Shaft Casing J.S.S. No. 38798

No. 388 - "Laurp Sodré"
4 mensur Report No. 11292
No. 389 - "Prudente de Moraes"

Shaft Casen's
 Russell & Co
 No. 387 78

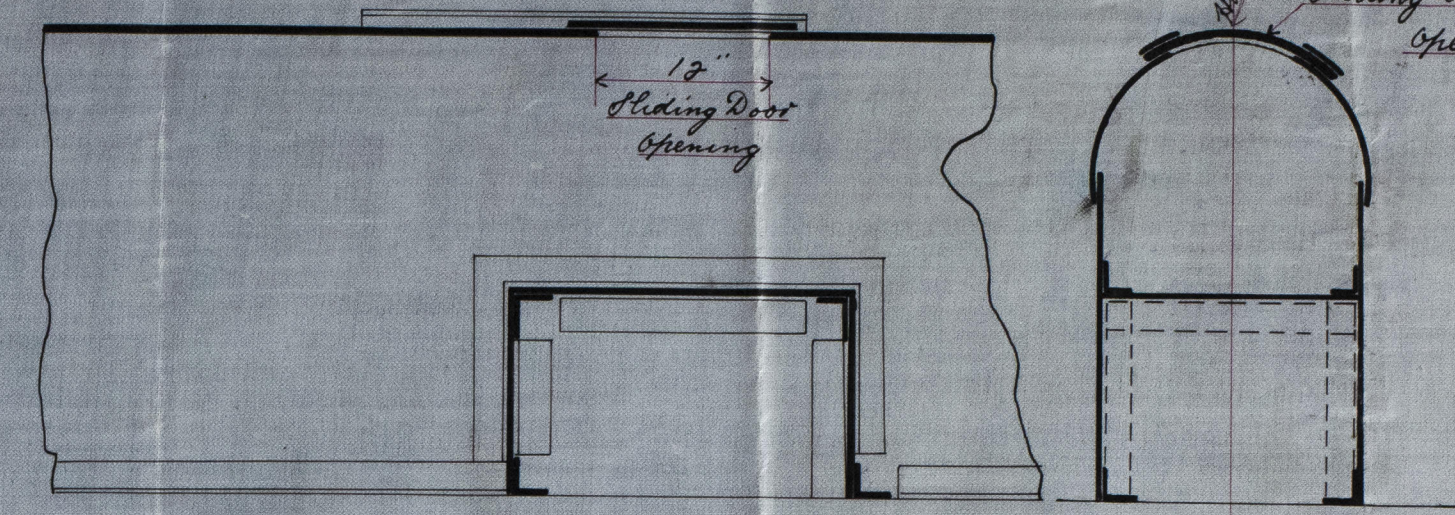
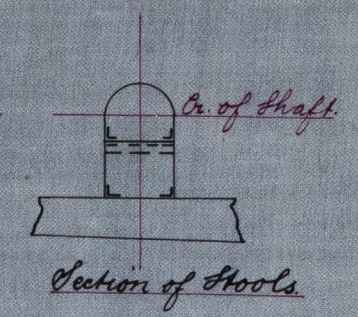
Means of access should be provided at couplings as well as at bearings
J.M. 24/10/95
